Before a Board of Inquiry
MacKays to Peka Peka Expressway Proposal

Statement of rebuttal evidence of **Noel Nancekivell** (Design – MacKays to Peka Peka Expressway) for the NZ Transport Agency

Dated: 25 October 2012

STATEMENT OF REBUTTAL EVIDENCE OF NOEL NANCEKIVELL FOR THE NZ TRANSPORT AGENCY

Title: PROPOSED EXPRESSWAY
TE MOANA RD TRAFFIC SIGNALS
CONCEPT DESIGN

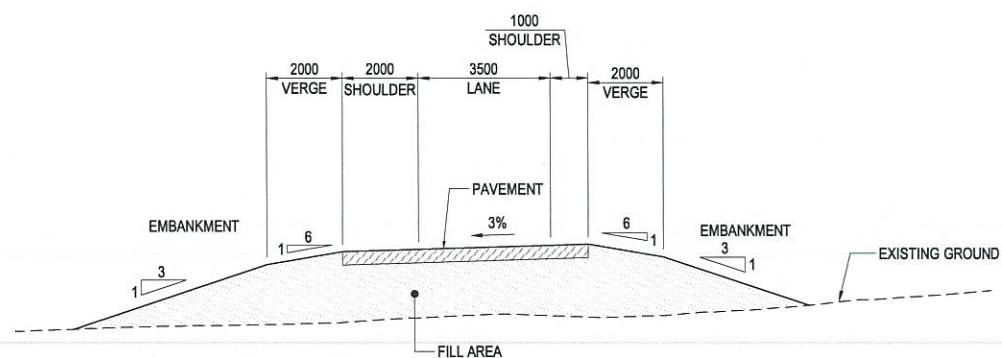
- 13 A number of the witnesses¹ for KCDC consider that traffic signals should be installed at the intersection of the on and off ramps with Te Moana Road. Currently the Expressway connects with Te Moana Road via two roundabouts and I discussed the consideration of controlling this intersection through traffic signals at paragraph 77 of my EIC.
- 14 In response to KCDC's evidence, plans have been developed showing traffic signals at this intersection and are attached to this statement of evidence as **Annexure A**. However, I wish to emphasise that these plans are indicative and the design of this intersection will require detailed input from traffic engineers (to confirm lane arrangement and ensure the required level of service is met). Urban and landscape designers will also need to have input into the design so as to allow comparison with the current round about design.

- 7 In response to *KCDC's* evidence, I note that:
 - 7.1 conceptual plans have been developed to begin consideration of the design of the intersection of the on and off ramps with Te Moana Road should traffic signals be required;
 - 7.2 the concepts developed for alternative access to Nga Manu have been appended to this statement; and

**ANNEXURE B – CROSS SECTION DRAWINGS CV-SC-020 TO
026 (LOCAL ROAD TYPICAL CROSS SECTION)**

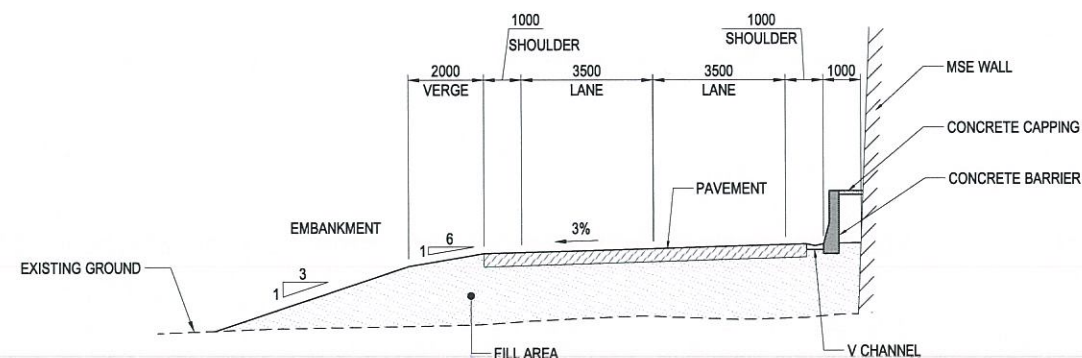
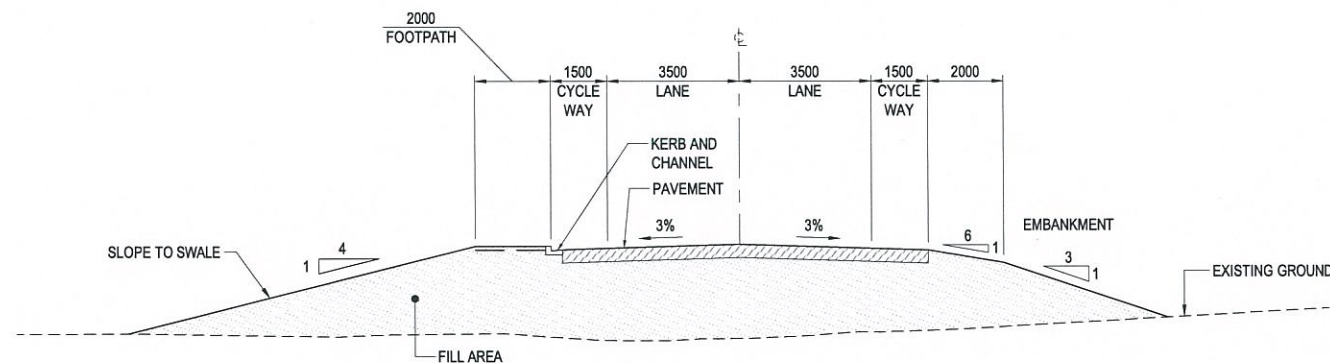
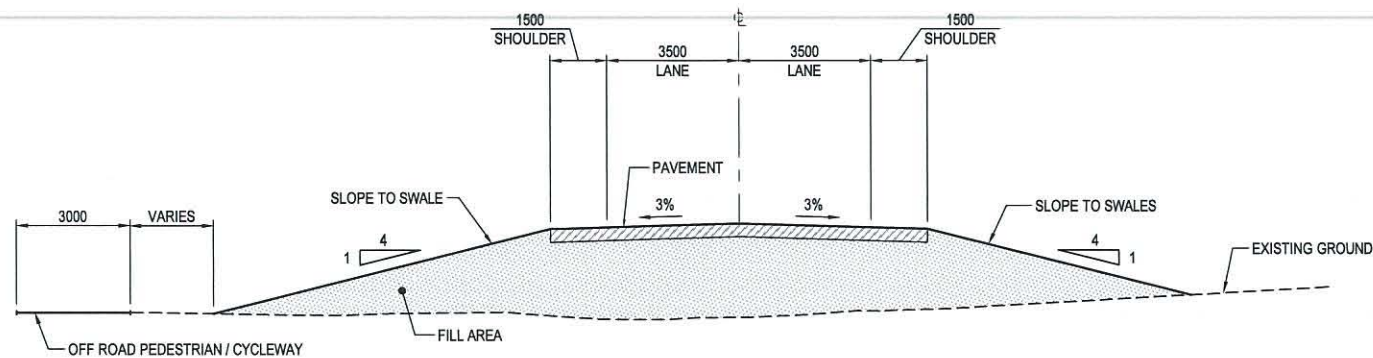
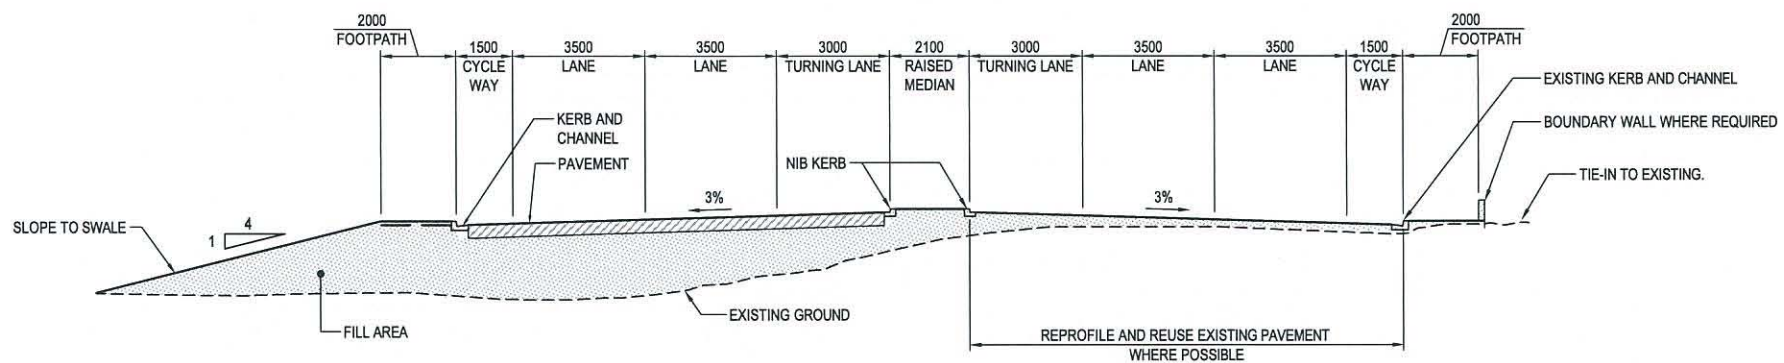
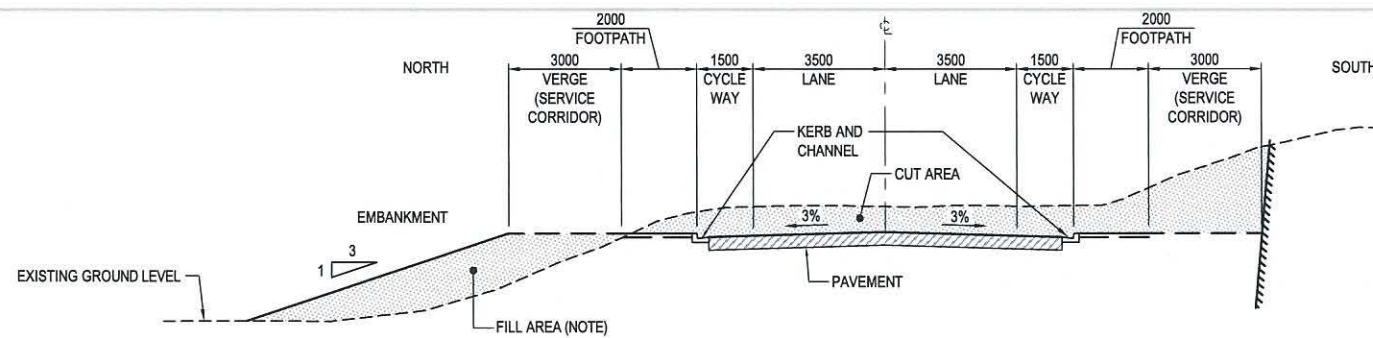
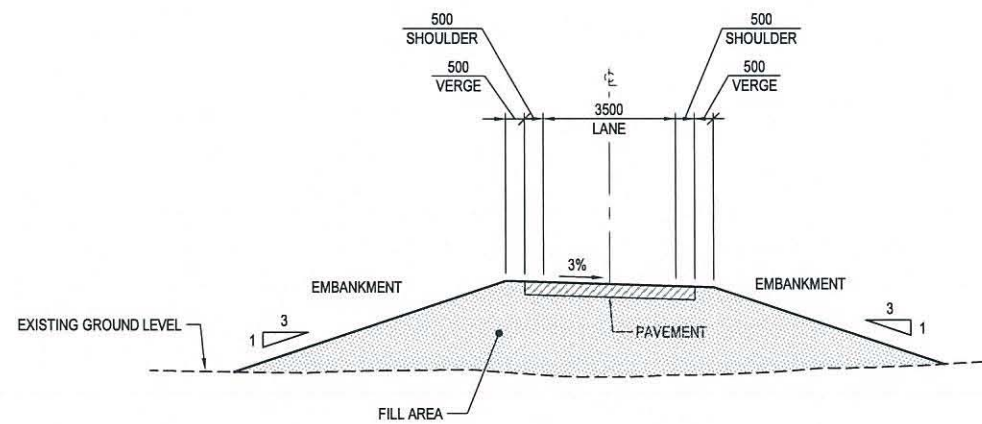
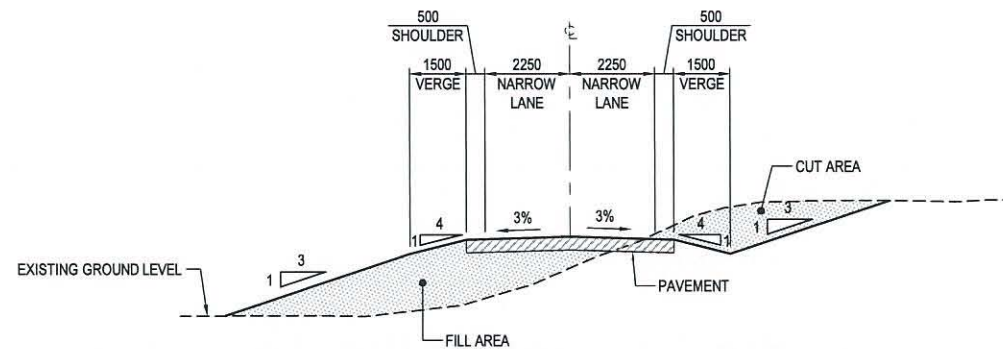
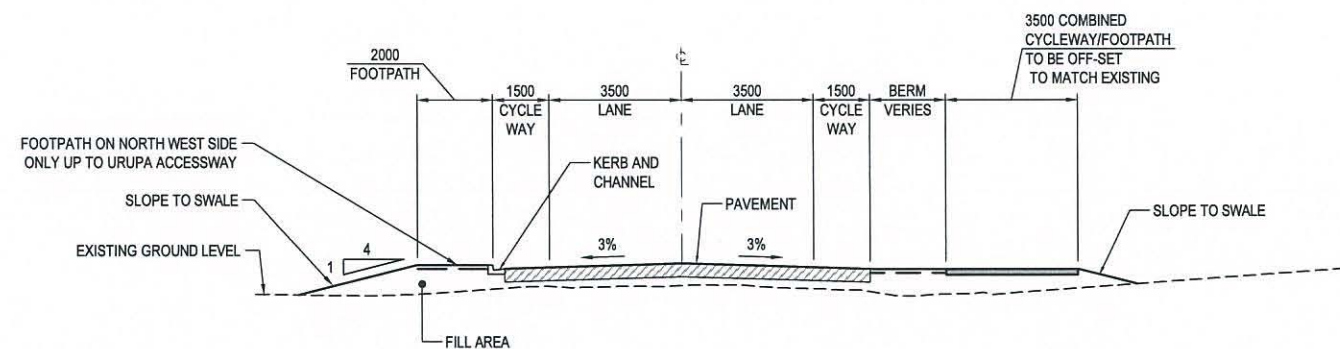
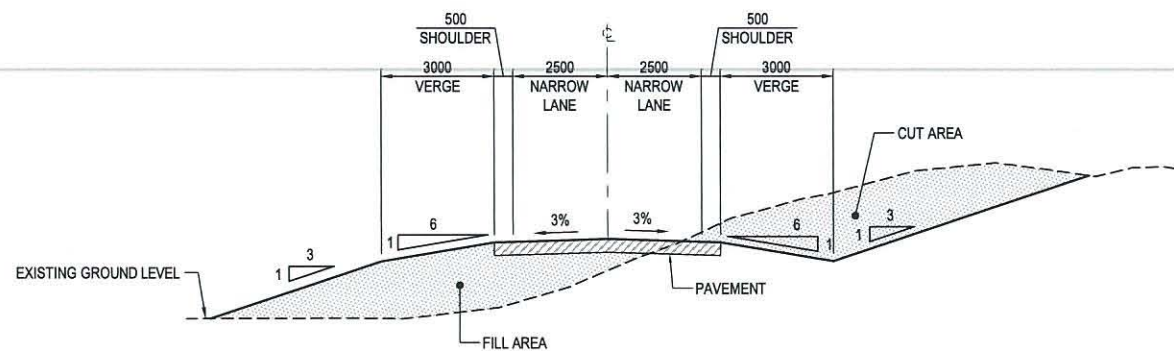
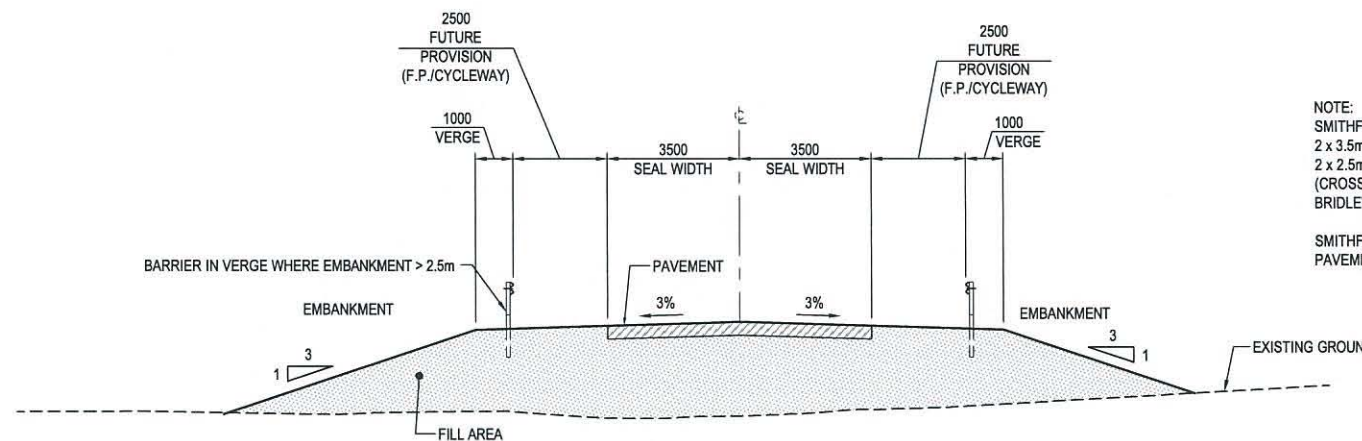
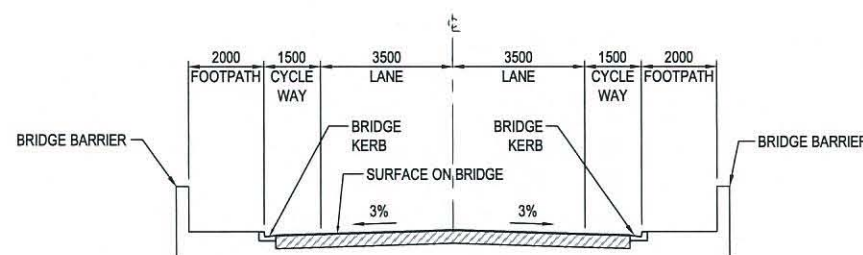
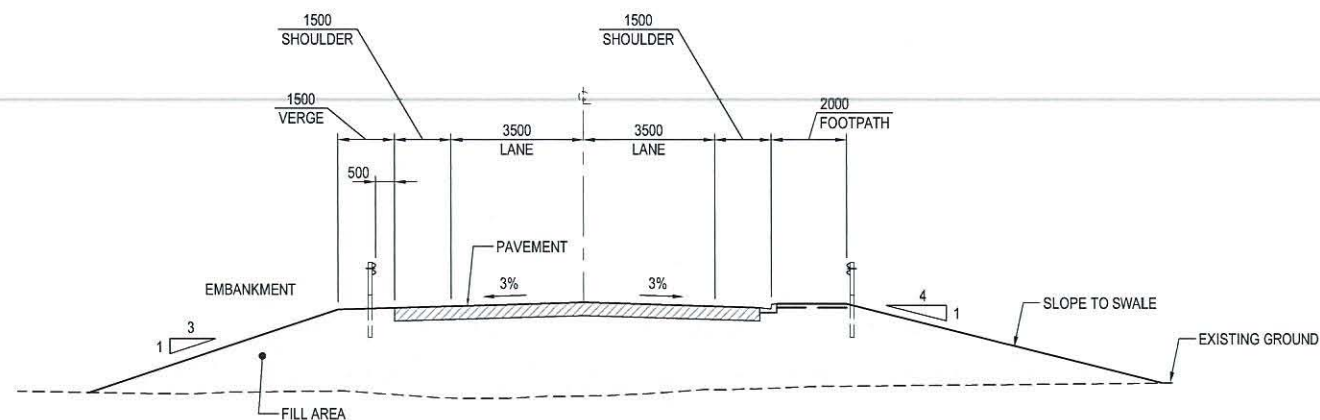
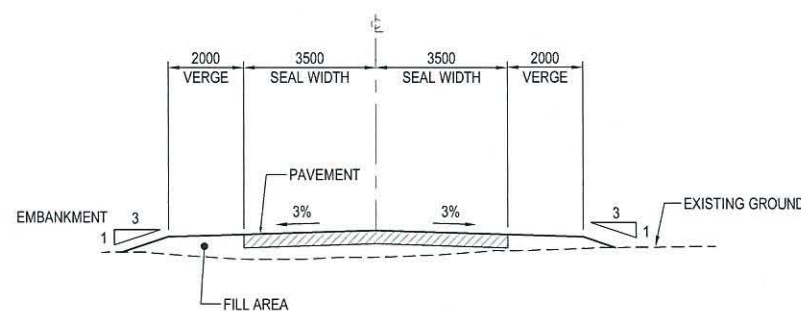
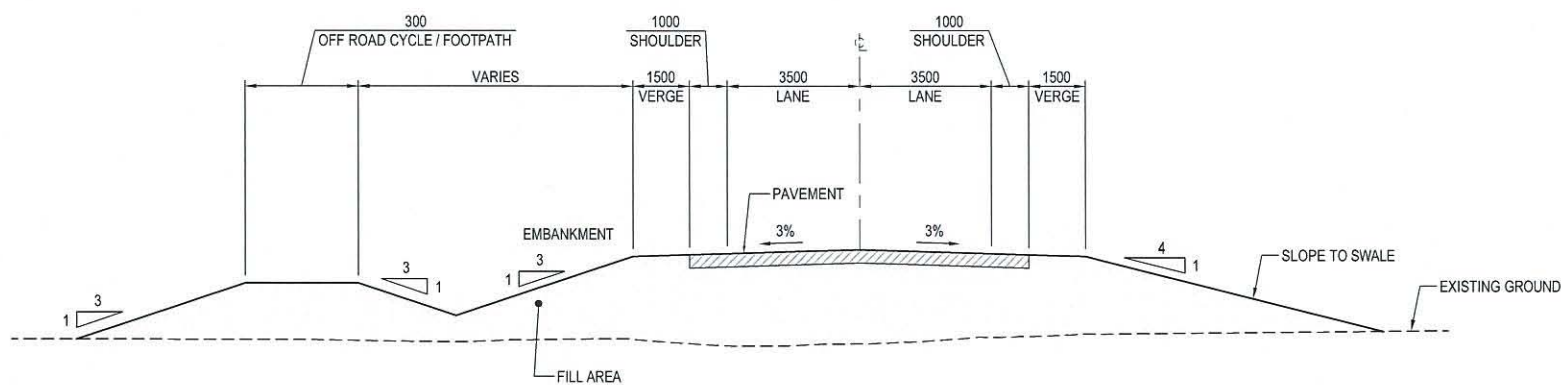
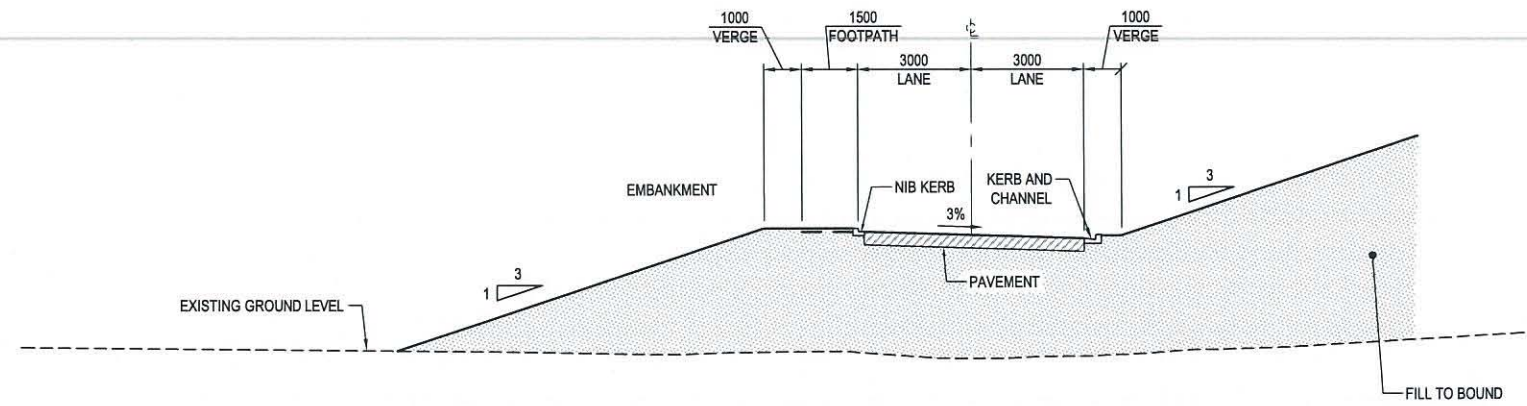
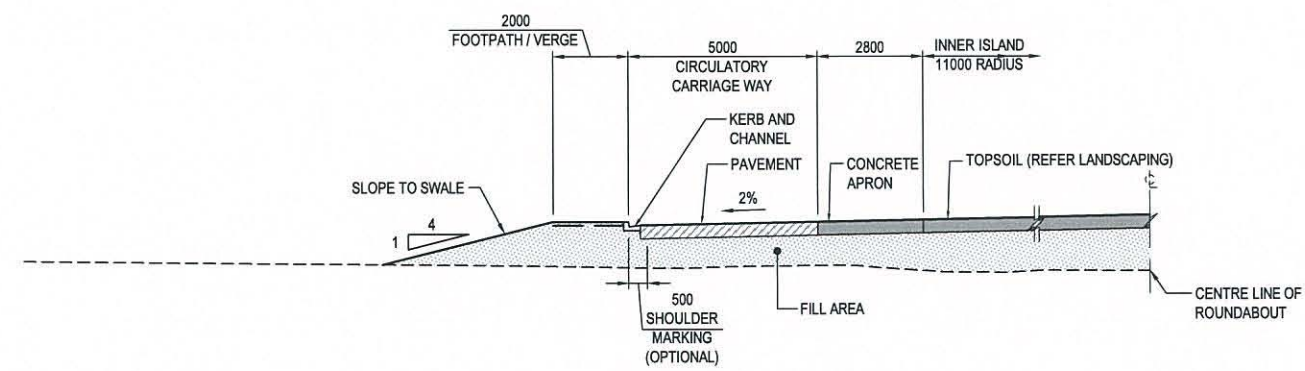
- 16 Section 7 of Mr Wignall's evidence discusses the proposed local road underpasses and bridges along the Expressway alignment. At paragraph 7.2, he states that:

Insufficient detail is provided in the application with respect to the standard of local crossings (underpasses and bridges) in terms of the width and height clearances to be allowed for future access, services, drainage, pedestrian, security and other needs.

- 17 KCDC has been involved in the development of the proposed local road under and over passes along the Expressway alignment. I acknowledge that this information was not provided as part of the assessment of environmental effects (AEE). However, bridge drawings ST-BR-100 to ST-BR-960 (provided in Folder 1, Volume 5 of the application documents) and the cross sections drawings CV-SC-020 to 026 (Local Road Typical Cross Section) Appendix A of the Scheme Assessment Report² include details for each local road crossing and bridge clearance. I have attached the cross section drawings as **Annexure B**.
